SK#06
07 pages
Date: 05-08-2025

PROJECT OWNER : 1250 MARYLAND AVENUE
PROJECT DESCRIPTION : 1250 MARYLAND AVENUE
PROJECT ADDRESS : 1250 MARYLAND AVENUE SW WASHINGTON,DC 20024
CONTRACTOR : BALFOUR BEATTY

DWG DESCRIPTION : ADHESIVE ANCHOR SETTING TYPES

Snap#01 from Model

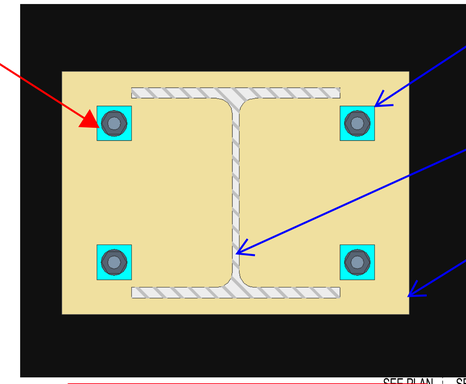
Q2

Please confirm the clouded weld for plate washer to base plate.

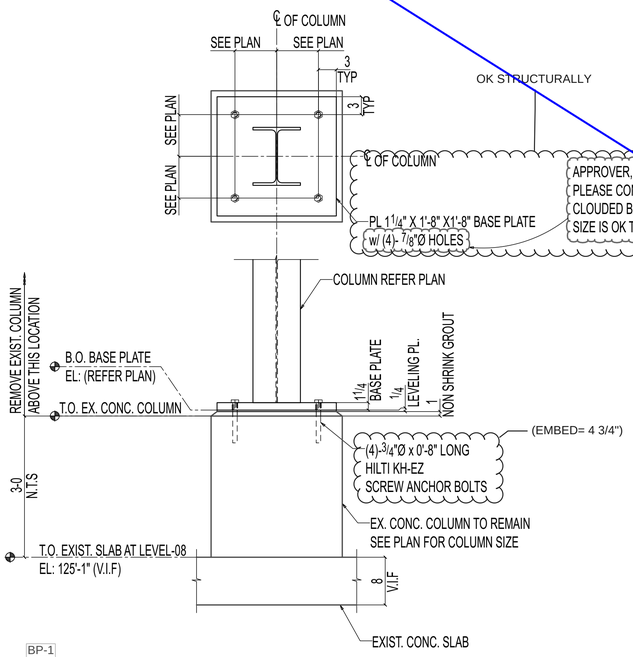
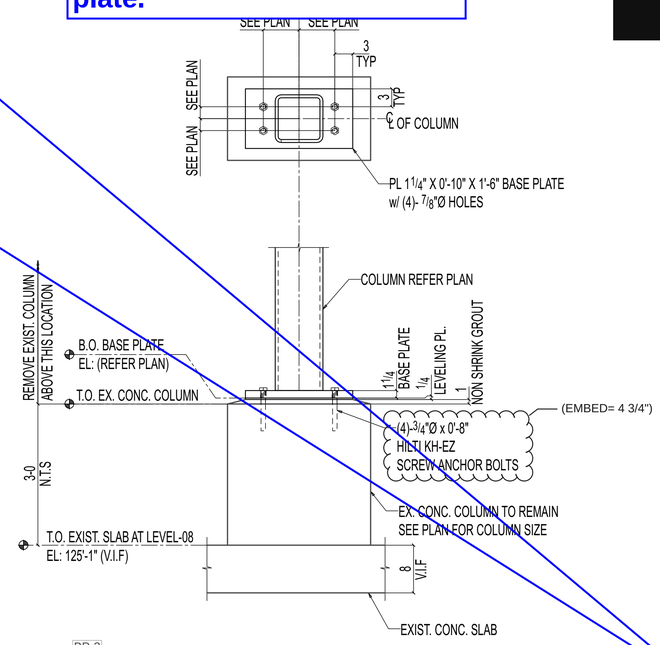
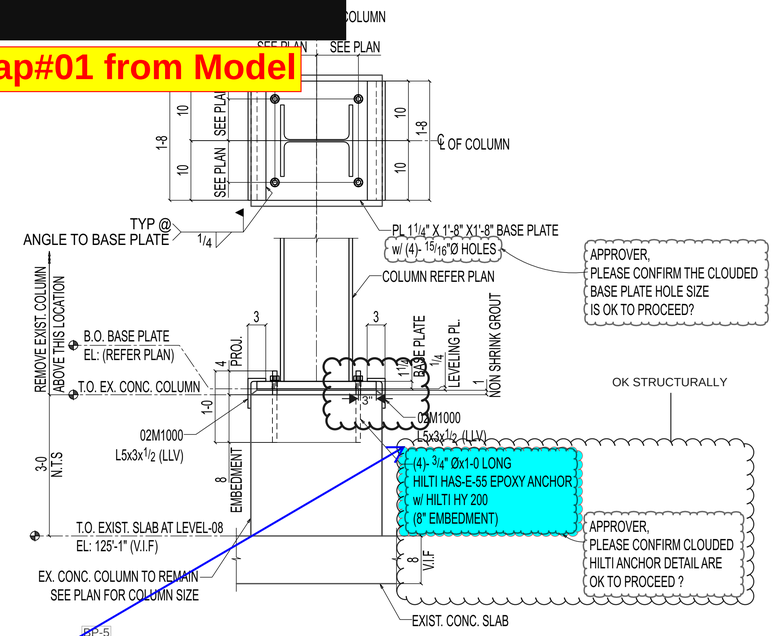
Q3

Per the green clouded note,
We will follow PL1/4"x2"x0-2" plate washer for 3/4"Ø hilti HAS-E-55 epoxy anchor at ALL columns in this project.
Please confirm.

APPROVER,
ALL SCREW ANCHOR LOCATIONS,
WE HAVE FOLLOWED 1" THICK
NON SHRINK GROUT.

APPROVER,
WE HAVE FOLLOWED 1/4" THK.
LEVELING PLATE FOR THIS PROJECT.
PLEASE CONFIRM.

OK STRUCTURALLY

DWG DESCRIPTION : ADHESIVE ANCHOR SETTING TYPES

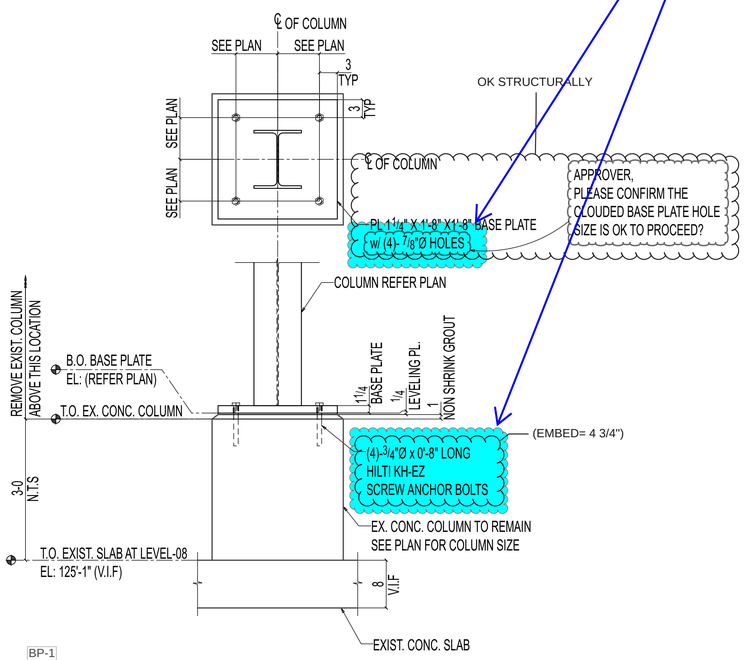
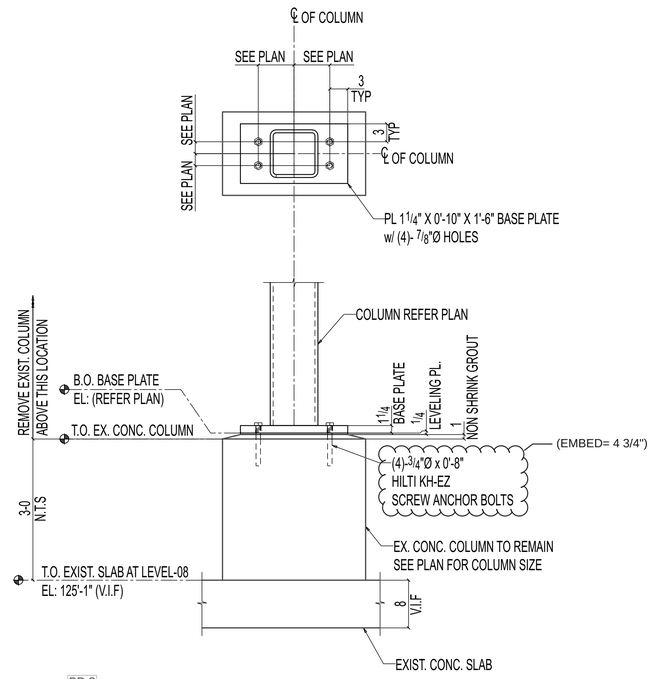
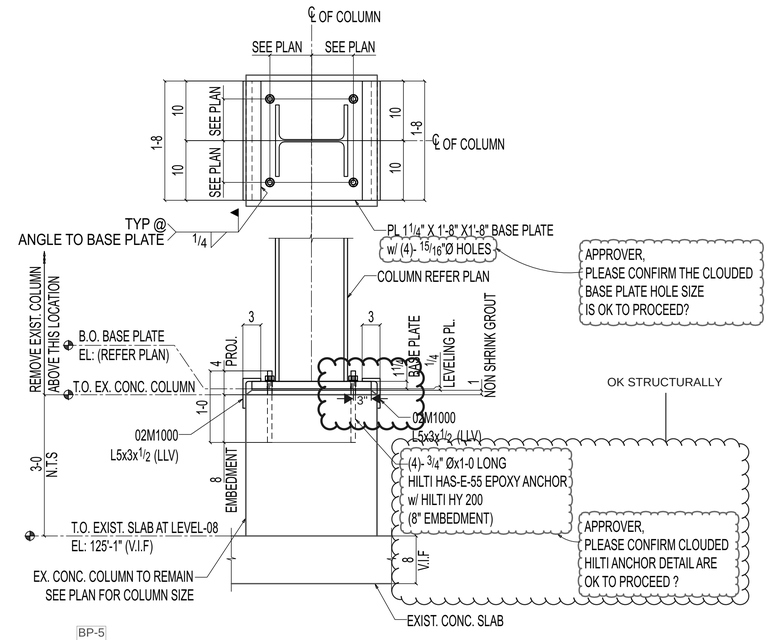
Q4

Please review & confirm if the 7/8Ø holes in the base plate for 3/4Ø KH-EZ screw anchors w/PL.1/4x2x0-2 plate washer are OK to proceed?

APPROVER, ALL SCREW ANCHOR LOCATIONS, WE HAVE FOLLOWED 1" THICK NON SHRINK GROUT.

APPROVER, WE HAVE FOLLOWED 1/4" THK. LEVELING PLATE FOR THIS PROJECT. PLEASE CONFIRM.

OK STRUCTURALLY

PARTIAL LEVEL-08 NEW STEEL COLUMN ADHESIVE ANCHOR PLAN-(PHASE-6) (SEQ#6)

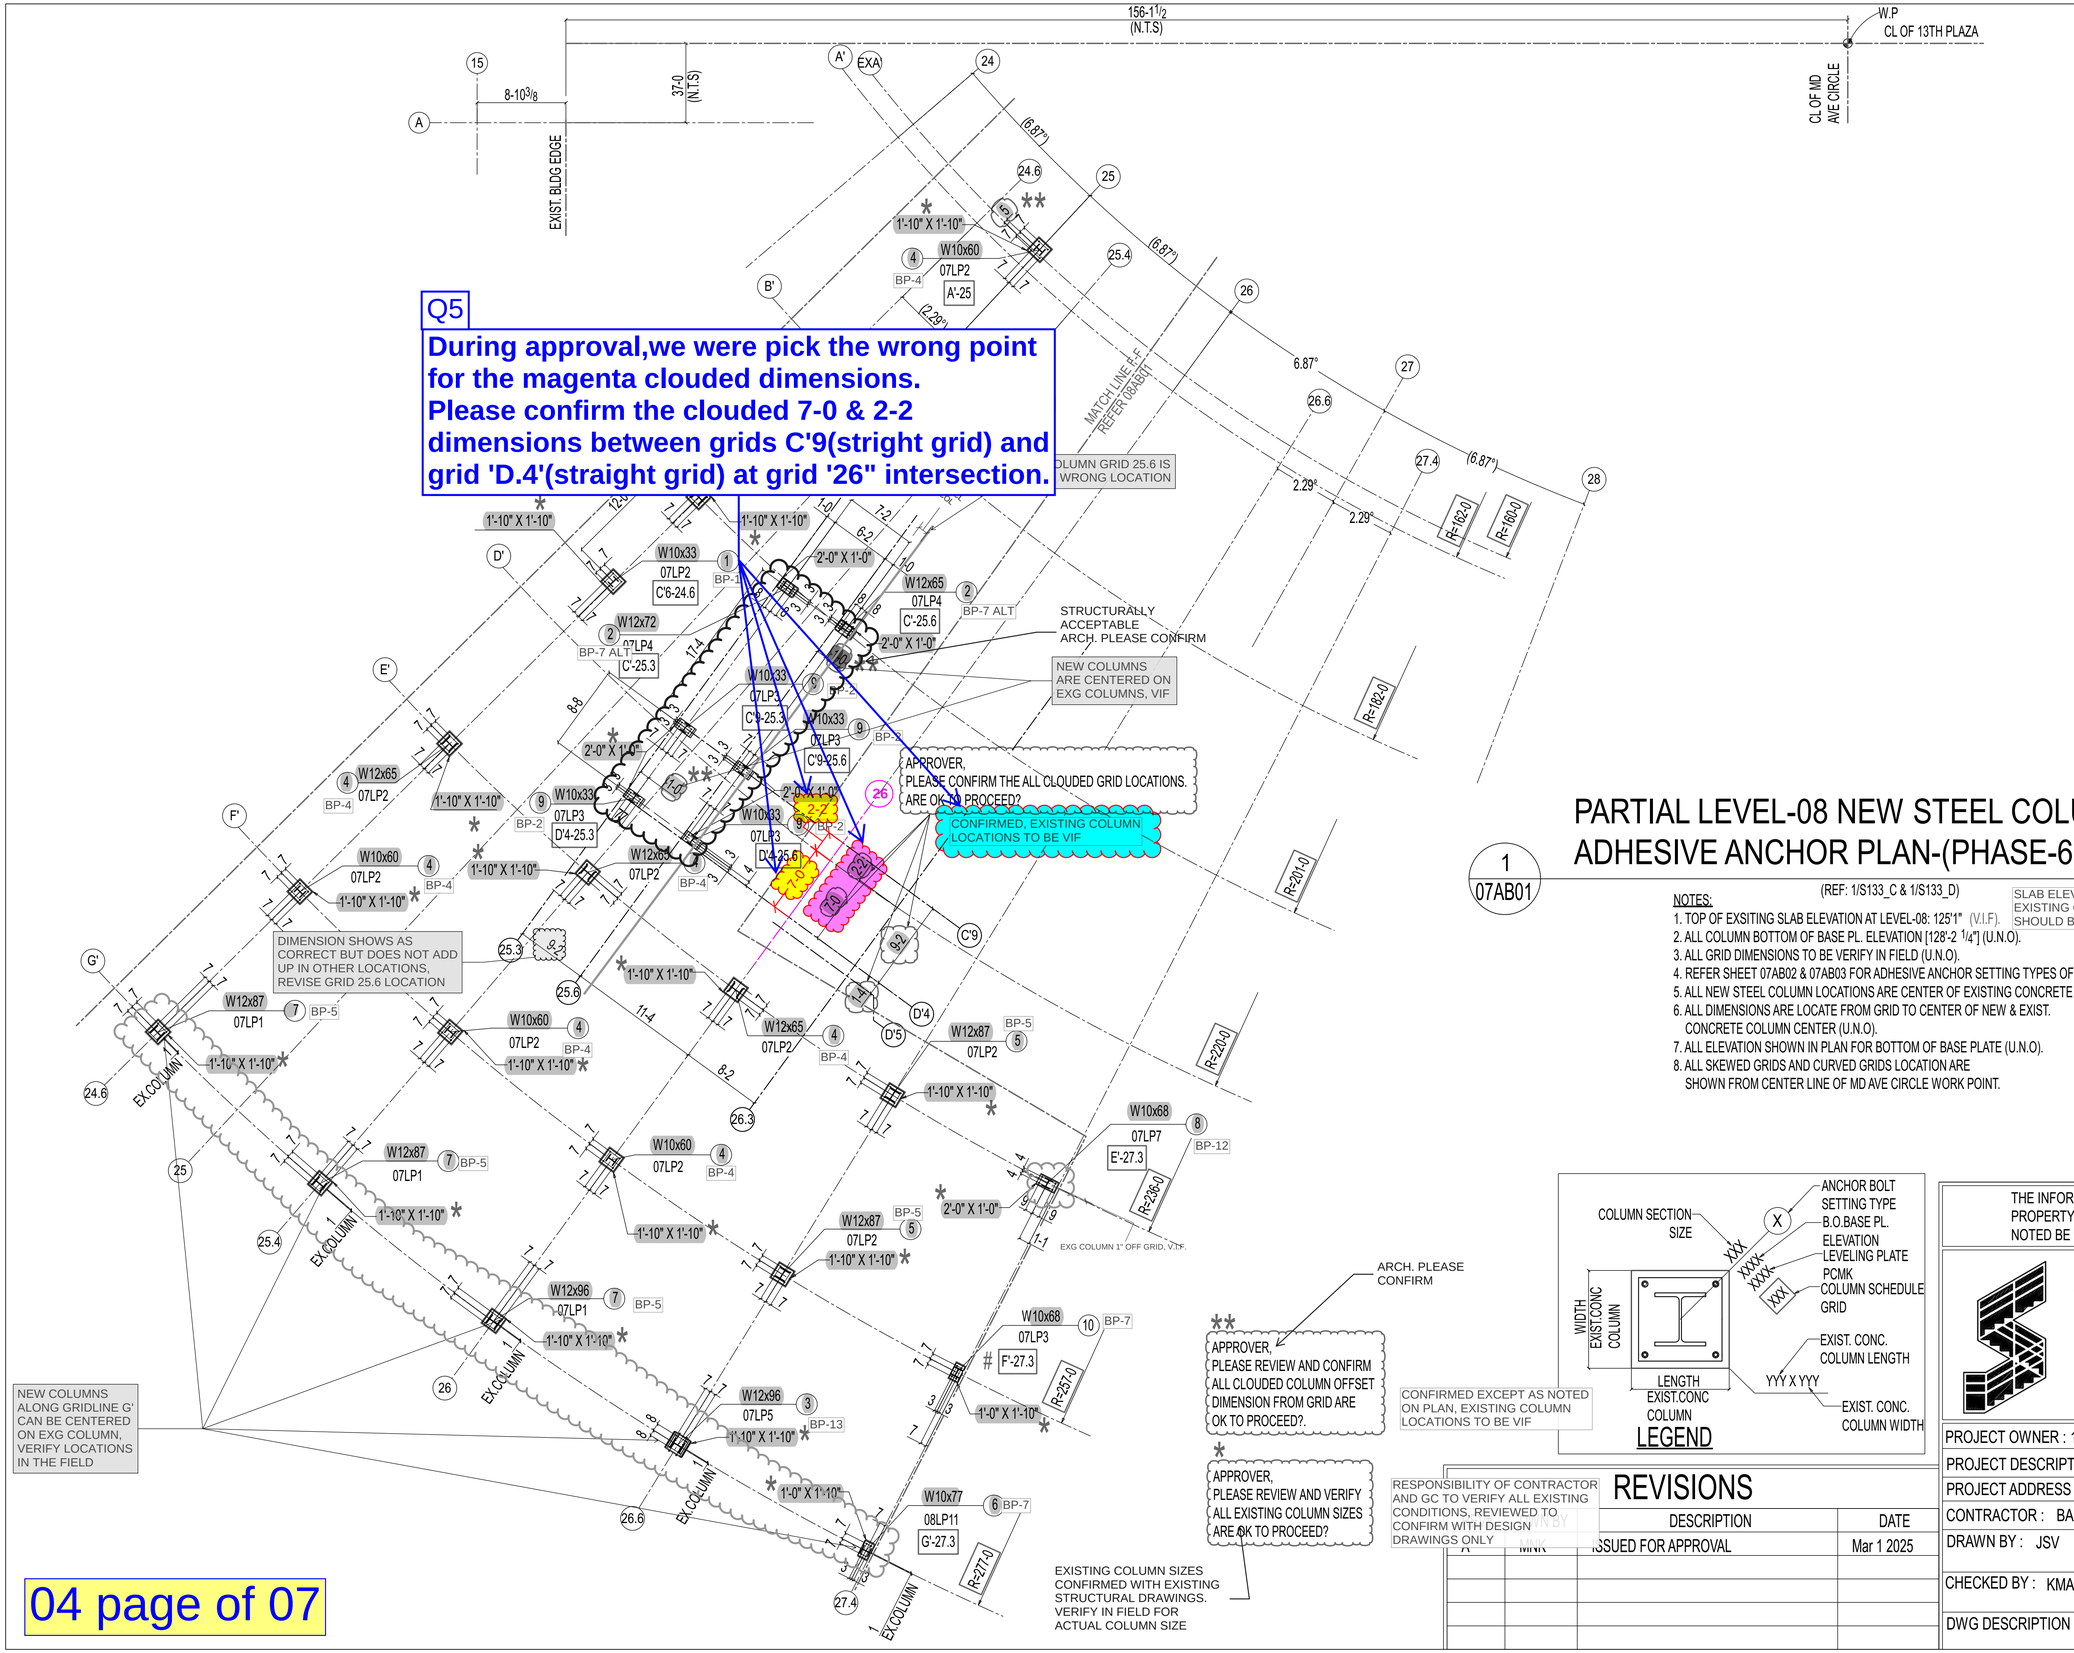
Q5

During approval,we were pick the wrong point for the magenta clouded dimensions. Please confirm the clouded 7-0 & 2-2 dimensions between grids C'9(stright grid) and grid 'D.4'(straight grid) at grid '26" intersection.

APPROVER,
PLEASE REVIEW AND CONFIRM
ALL CLOUDED DIMENSION & ANGLE
FOR THE SKEWED GRID INTERSECTION
POINT ARE OK TO PROCEED?

APPROVER,
PLEASE VERIFY AND CONFIRM, WE HAVE ASSUMED THAT THE
CLOUDED,COLUMN LOCATION DERECTLY SEATED
ON THE IN EXISTING CONCRETE SLAB, SINCE
LATEST SURVEY DRAWING DOES NOT SHOWN
EXISTING CONCRETE COLUMN FOR THIS LOCATION.

NOT SURE WHAT THIS IS MEASURING

CONFIRMED EXCEPT AS NOTED ON PLAN

ARCH. PLEASE CONFIRM

Snap from architectural drawing 1/A002 (Grid plan)

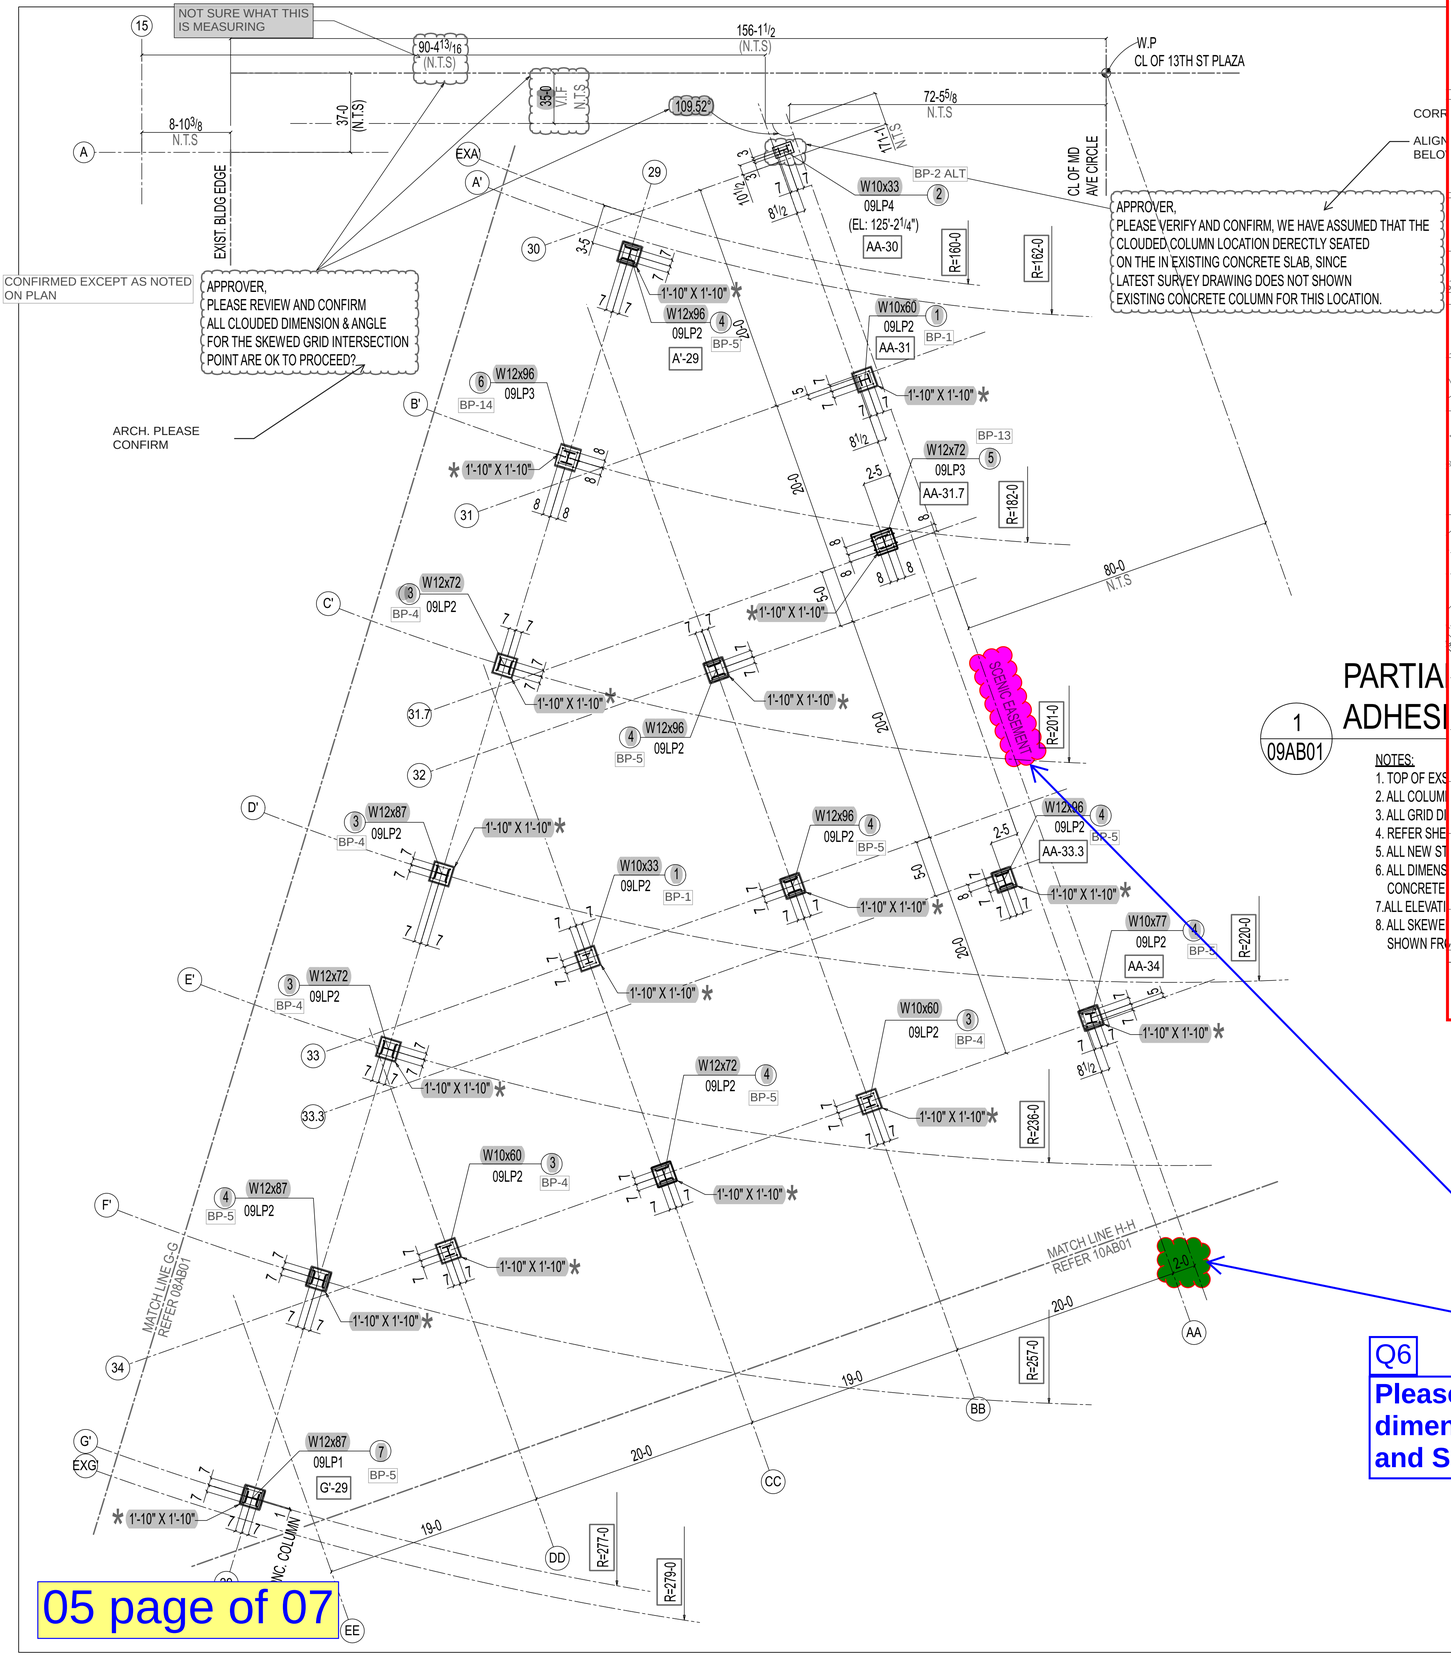
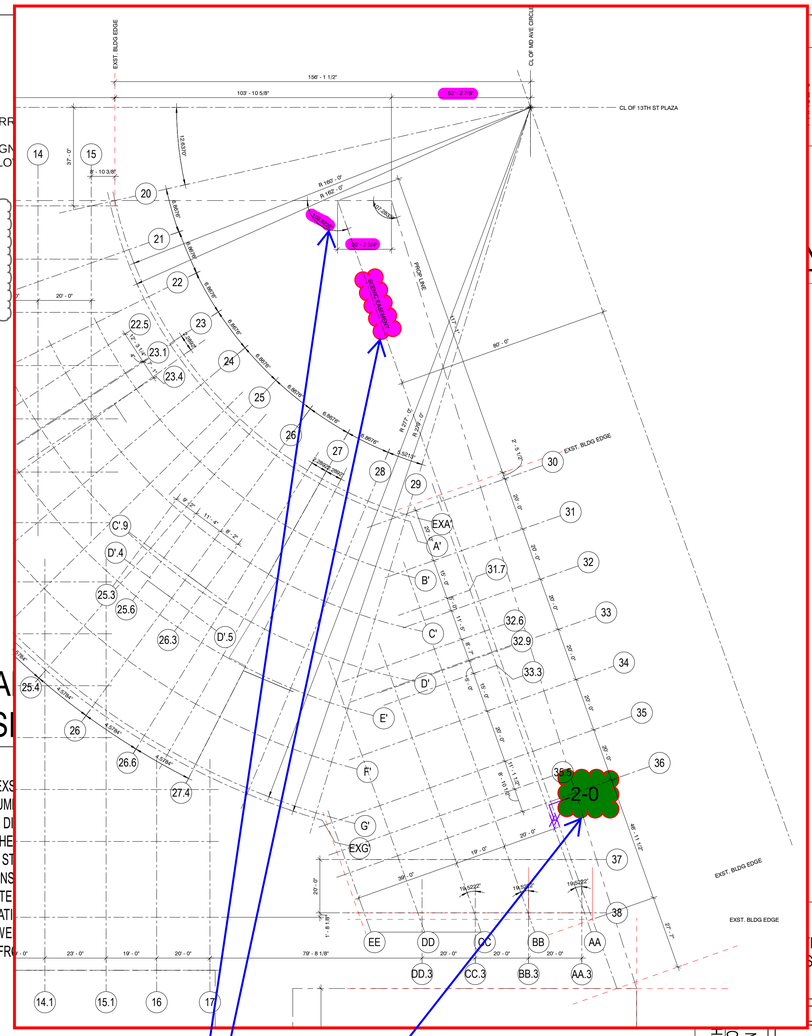
APPROVER,
PLEASE REVIEW AND VERIFY
ALL EXISTING COLUMN SIZES
ARE OK TO PROCEED?

Q6

Please confirm the green clouded dimension between grid "AA" and Scenic easement line.

RESPONSIBILITY OF CONTRACTOR AND GC TO VERIFY ALL EXISTING CONDITIONS, REVIEWED TO CONFIRM WITH DESIGN DRAWINGS ONLY

COLUMN SIZES
ED WITH EXISTING
RAL DRAWINGS.
FIELD FOR
OLUMN SIZE

DWG DESCRIPTION : ANGLE DETAIL

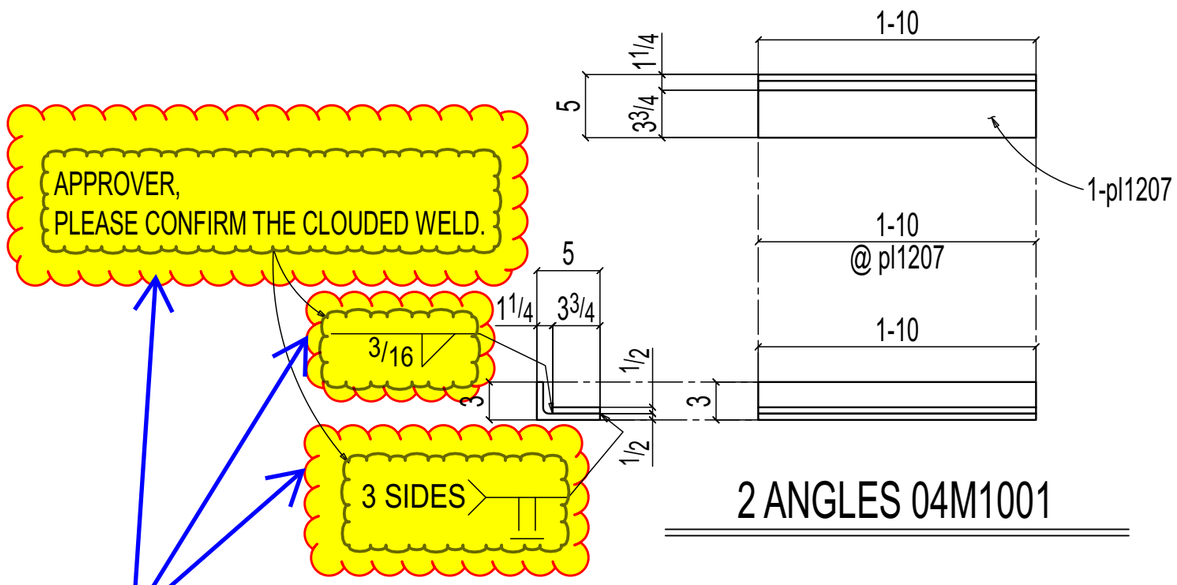
Q8

Please review the clouded welds and confirm.
